# A47 North Tuddenham to Easton Dualling

## **9.15 Alternative Wood Lane Junction Options Appraisal**

**ALTERNATIVE WOOD LANE JUNCTION OPTIONS APPRAISAL**

<b>Regulation Number:</b>	Rule 8(1)(c)
<b>Planning Inspectorate Scheme Reference</b>	TR010038
<b>Application Document Reference</b>	TR010038/EXAM/9.15
<b>BIM Document Reference</b>	HE551489-GTY-HGN-000-RP-CH-30012
<b>Author:</b>	A47 North Tuddenham to Easton Project Team, Highways England

Figure 2-3: Wood Lane Junction Alternative 1

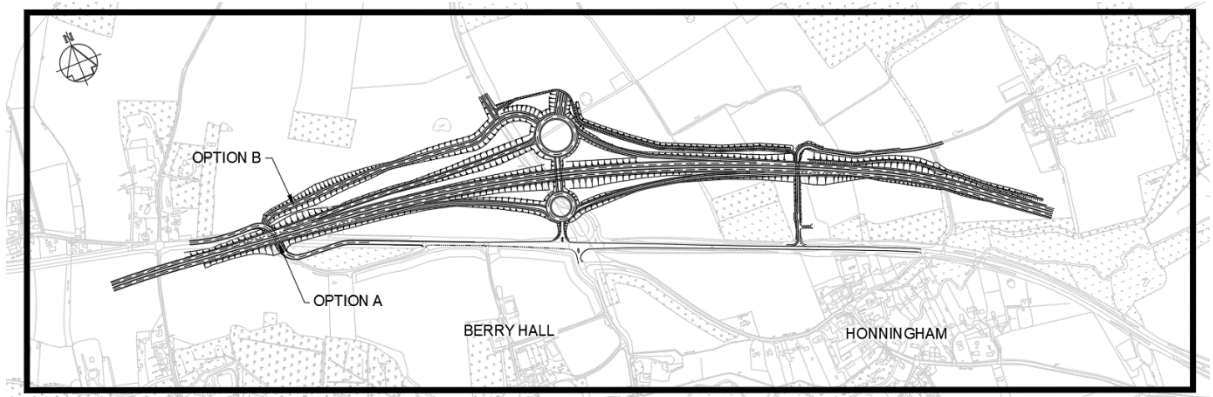
3.2.4 The mainline horizontal geometry shown is generally above the desirable minimum radius for a 120kph design speed and therefore complies with the required standards.

3.2.5 The exception to this is the 990m horizontal radius used at the eastern tie-in to the developed design. This falls one step below desirable minimum horizontal radius of 1,020m required of a 120kph design speed road and is therefore a horizontal relaxation.

- 3.2.6 As this relaxation occurs in advance of the junction diverge slip, widening to provide full stopping sight distance would be necessary to avoid this being classified as a departure from the standard (CD 109, Clause 2.13).

This has not been accounted for in the alternative design and would increase permanent land take accordingly.

- 3.2.7 It is also worth noting that the new mainline alignment would be closer to properties at Hall Farm, thus increasing likely noise impacts for properties already predicted to experience a significant adverse residual noise effect during operation of the Scheme design; see Environmental Statement Chapter 11 Noise and Vibration (**APP-150**).

Option A, with Lady's Grove underpass, would also bring the proposed existing A47 side road closer to Hillcrest Cottage compared to the Scheme design.

- 3.2.17 The vertical design needs to provide clearance for a junction underbridge and farm underpass that are to be provided in this option, in similar locations to those required in the Scheme design.

- 3.2.18 An additional underbridge is required in this option to maintain the existing A47. Such an underpass would require a headroom of 5.3m. Provision of this compliant headroom would require the proposed dualled A47 to be raised by approximately 5.5m.

- 3.2.19 The mainline would require to be raised above the Scheme design levels for a length of approximately 1,200m, with additional earthworks/materials and increased environmental impacts, especially landscape, visual and noise for properties around Church Lane, Sandy Lane and Park Lane, over this extent as a result; in particular, there is a risk the effectiveness of the proposed noise barrier mitigation north of Church Lane could be compromised as mitigation for properties at risk of significant noise impacts from the Scheme design.

- 3.2.20 The vertical design needs to provide clearance for a junction underbridge and farm underpass that are to be provided in this option, in similar locations to those required in the Scheme design.

- 3.3.13 Indicative slip roads are shown to a similar length of the Scheme design, but do not take into account that the A47 mainline levels would require to be raised west of the junction to accommodate the proposed Lady's Grove underpass carrying the existing A47.

- 3.3.14 The eastbound diverge and westbound merge slips would not meet the DMRB requirements in their current form, due to the increased level difference to be overcome between the junction roundabout(s) and the mainline.

- 3.3.15 Based on the current slip road lengths a non-compliant vertical profile would be required to meet this level difference, resulting in critical departures from standard for both vertical geometry and stopping sight distance.

- 3.3.16 Compliant slip roads would only be possible for this alternative layout by significantly increasing the length of the slip roads, resulting in increased land take and associated increase in environmental impacts.

- 3.3.18 Indicative slip roads are shown to a similar length as the Scheme design, as this option has comparable constraints, and the lengths indicated appear to meet the DMRB requirements, though no assessment of vertical alignment has been carried out.

- 3.3.31 No road markings have been provided for the link from the Existing A47 (Detrunken) to the southern roundabout, however from reviewing the widths shown in the drawing this suggests a ghost island junction will be provided.

For an 85kph Design Speed, the 38m spacing of this left/right staggered junction is less than required by CD 123, Clause 2.25 and will require a Departure from Standard.

Additionally, this layout cannot provide the 55m deceleration lengths for either junction, requiring a further Departure from Standard to CD 123, Clause 5.22.

- 3.3.32 The proposed junction of the B1535 Wood Lane with the western A47 link from the northern roundabout is shown as a simple priority junction. This junction is located on a sharp curve (Radius 80m) which is advised against in CD 123, Clause 2.1.1:

Following CD 123 Figure 2.3.1 this “should”<sup>4</sup> be a ghost island junction, this is likely to cause conflicts between the traffic exiting the roundabout and that queuing to turn right into Wood Lane.

This combination of relaxations given the location and proximity of the junctions leads to safety concerns which would require the approval of the Local Highway Authority.

The proposals do not allow for verge widening for visibility therefore it is assumed that junction visibility and additional land take has not been allowed for within the alternative design and would require further review.

Figure 2-4: Wood Lane Junction Alternative 2

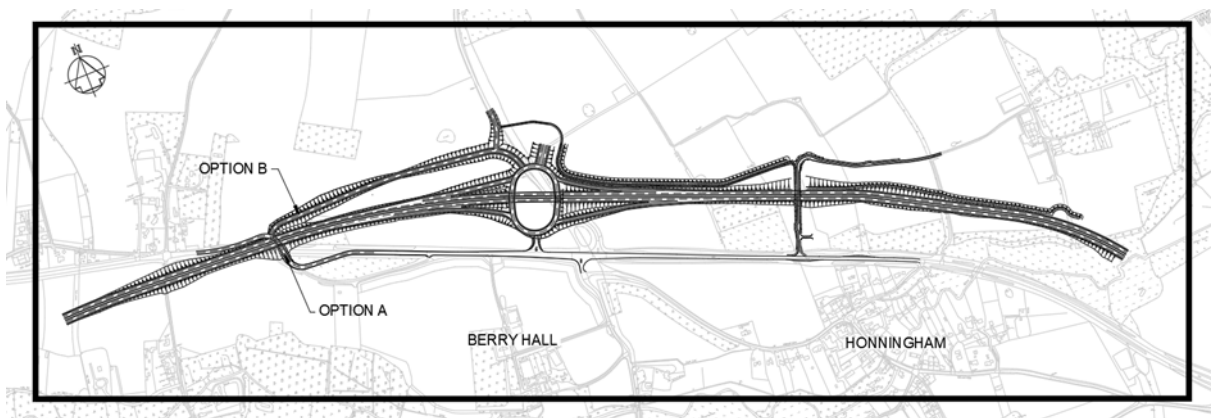
- 3.2.8 The mainline horizontal geometry shown falls below the desirable minimum radius for a 120kph design speed in 2 locations.

- A 720m horizontal radius is used east of the farm access underpass.
- A 720m horizontal radius is used at the eastern tie-in to the developed design.

- 3.2.9 Both these fall one step below desirable minimum horizontal radius of 1,020m required of a 120kph design speed road and are therefore horizontal relaxations.

As these relaxations occur in advance of the junction diverge slip, widening to provide full stopping sight distance would be necessary in order to avoid this being classified as a departure from the standard (CD 109, 2.13).

This has not been accounted for in the alternative design and would increase permanent land take accordingly.

- 3.2.10 Option A, with Lady's Grove underpass, would also bring the proposed existing A47 side road closer to Hillcrest Cottage compared to the Scheme design.

- 3.2.21 The vertical design needs to provide clearance for a farm underpass to be provided in this option, in a similar location to that required in the Scheme design.

- 3.2.22 The vertical design also needs to provide clearance for two junction underbridges that replace the single structure of the Scheme design.
- 3.2.23 An additional underbridge is required in this option to maintain the existing A47. Such an underpass would require a headroom of 5.3m. Provision of this compliant headroom would require the proposed dualled A47 to be raised by approximately 5.5m.

- 3.2.24 The mainline would require to be raised above the Scheme design levels for a length of approximately 1,200m, with additional earthworks/materials and increased environmental impacts, especially landscape, visual and noise for properties around Church Lane, Sandy Lane and Park Lane, over this extent as a result; in particular, there is a risk the effectiveness of the proposed noise barrier mitigation north of Church Lane could be compromised as mitigation for properties at risk of significant noise impacts from the Scheme design.

- 3.2.25 The vertical design needs to provide clearance for a farm underpass to be provided in this option, in a similar location to that required in the Scheme design.
- 3.2.26 The vertical design needs to provide clearance for two junction underbridges that replace the single structure of the Scheme design.

- 3.3.19 Indicative slip roads are shown to a similar length of the Scheme design, but do not take into account that the A47 mainline levels would require to be raised west of the junction to accommodate the proposed Lady's Grove underpass carrying the existing A47.
- 3.3.20 The eastbound diverge and westbound merge slips would not meet the DMRB requirements in their current form, due to the increased level difference to be overcome between the junction roundabout(s) and the mainline.
- 3.3.21 Based on the current slip road lengths a non-compliant vertical profile would be required to meet this level difference, resulting in critical departures from standard for both vertical geometry and stopping sight distance.

- 3.3.22 Compliant slip roads would only be possible for this alternative layout by significantly increasing the length of the slip roads, resulting in increased land take and associated increase in environmental impacts.
- 3.3.23 The increased lengths in slip roads may require the alternative mainline A47 to move further south, which would impact the proposed Wood Lane Junction location with a similar shift to the south, resulting in operational difficulties with the proposed junction on the existing A47 south of Wood Lane junction.

- 3.3.24 Indicative slip roads are shown to be significantly shorter than the Scheme design, as this option has similar constraints, the lengths indicated do not meet the DMRB requirements in their current form.

- 3.3.25 Based on the current slip road lengths a non-compliant vertical profile would be required to meet this level difference, resulting in critical departures from standard for both vertical geometry and stopping sight distance.

- 3.3.26 Compliant slip roads would only be possible for this alternative layout by significantly increasing the length of the slip roads, resulting in increased land take and associated increase in environmental impacts.

- 3.3.33 No road markings have been provided for the link from the Existing A47 (Detrunken) to the southern roundabout, however from reviewing the widths shown in the drawing this suggests a ghost island junction will be provided.

For an 85kph Design Speed, the 108m spacing of this left/right staggered junction meets the requirements of CD 123, Clause 2.25 for spacing and CD 123, Clause 5.22 for the deceleration lengths.

- 3.3.34 The proposed junction of the B1535 Wood Lane with the western A47 link from the northern roundabout is shown as a simple priority junction. This junction is located on a sharp curve (Radius 80m) which is advised against in CD 123, Clause 2.1.1:

Following CD 123, Figure 2.3.1 this “should” be a ghost island junction, this is likely to cause conflicts between the traffic exiting the roundabout and that queuing to turn right into Wood Lane.

This combination of relaxations given the location and proximity of the junctions leads to safety concerns which would require the approval of the Local Highway Authority.

The proposals do not allow for verge widening for visibility therefore it is assumed that junction visibility and additional land take has not been allowed for within the alternative design and would require further review.
